SERVICE BULLETIN

SERVICE BULLETIN NO. 20

INSPECTION OF TRIM TAB HORN AND ROD ATTACHMENT

SUPPEMENT NO. 1
SERVICE BULLETIN NO. 20
NOVEMBER 10, 1947

NOTE: A sketch of the bushing (see Figure 1) is reproduced to expedite immediate repair. If facilities are not at hand to accomplish this, these bushings will be available to you through your distributor at no charge.

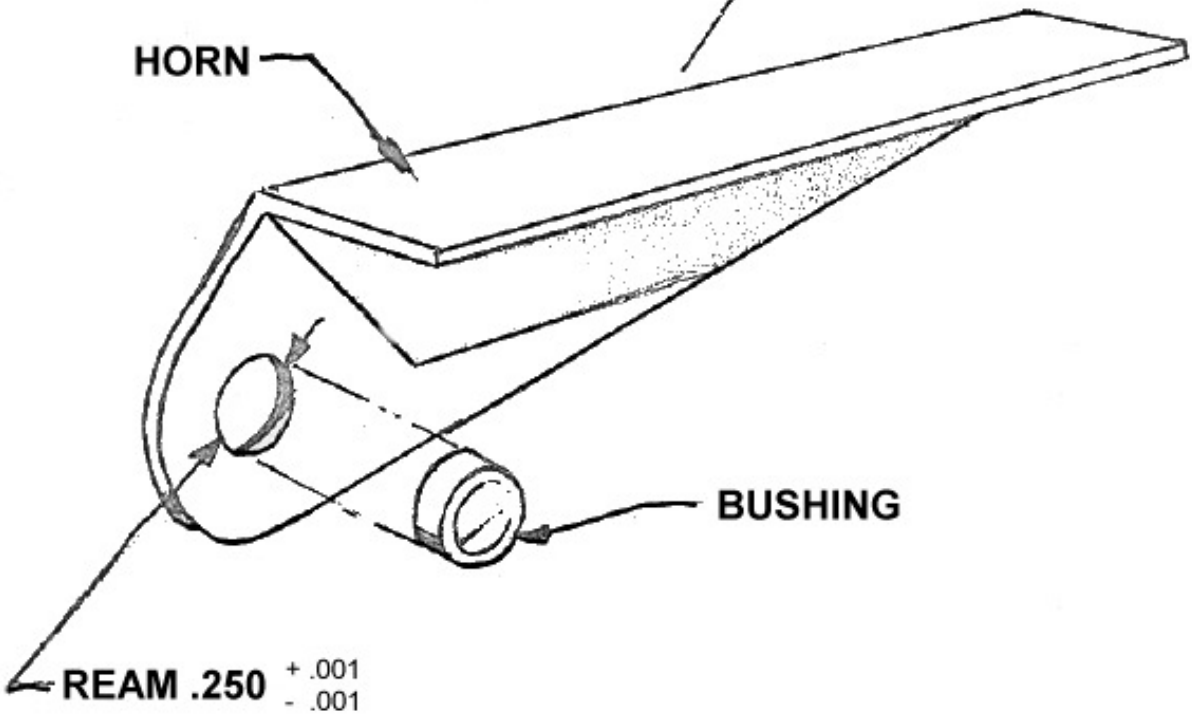
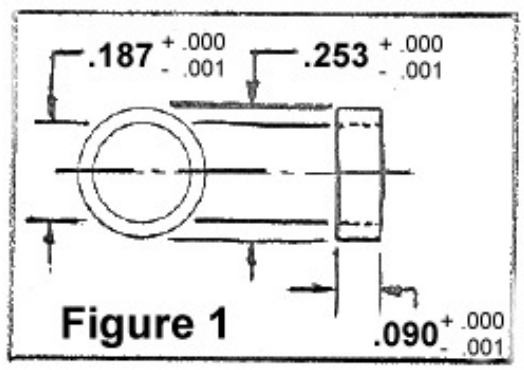
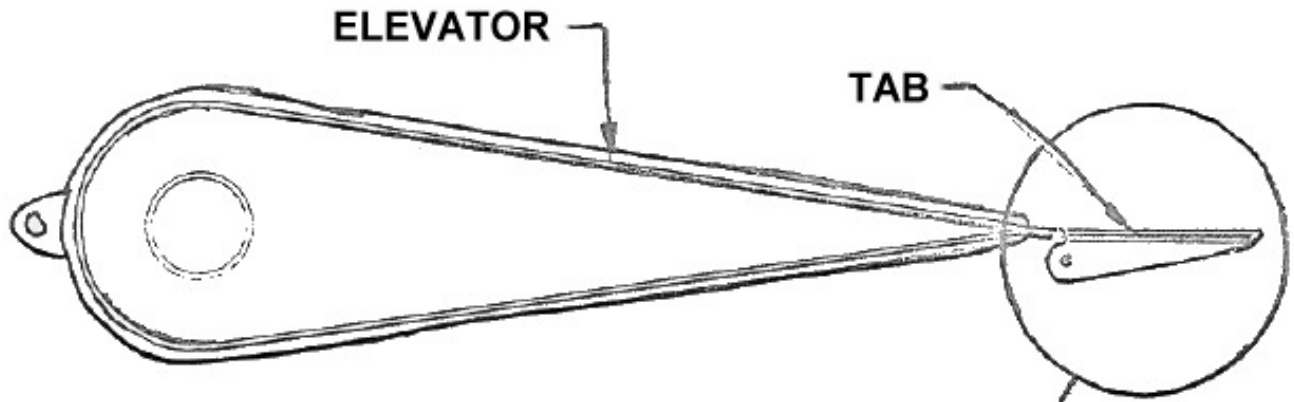
Reason for Change: An investigation of several recent reports of excessive vibration or buffeting in flight disclosed a wearing or elongation of the trim tab horn attaching hole which permitted play in the tab and resulted in the unsatisfactory flight characteristics such as elevator chatter.

Hold control rod forward of the attaching clevis fitting and check trim tab for play at the attachment. A maximum of 1/8" play is permissible when measured vertically at the trailing edge of the trim tab.

In the event the hole is found to have worn, permitting excessive play between the control rod and tab, the following repair should be accomplished:

1. Remove the cotter key and pin from the clevis fitting.
2. Enlarge hole in tab to 15/64".
3. Ream to $.250 \pm .001$.
4. Use a pair of parallel pliers or a suitable clamp to press the bushing into the hole.
5. Reassemble and lubricate the attachment,
6. Make suitable notation of compliance in the Aircraft Log Book.

1. For fabrication of the bushing described in Service Bulletin No. 20 use the following material:

5/16 dia., .065 thick – Seamless steel tubing – Cad. Plate.

2. When reaming the bushing hole maintain a minimum distance of 5/32" at the radius edge of the trim tab. In the event it is found at the time of inspection that the previous wear will not permit holding to this tolerance, a replacement horn will have to be ordered and installed.
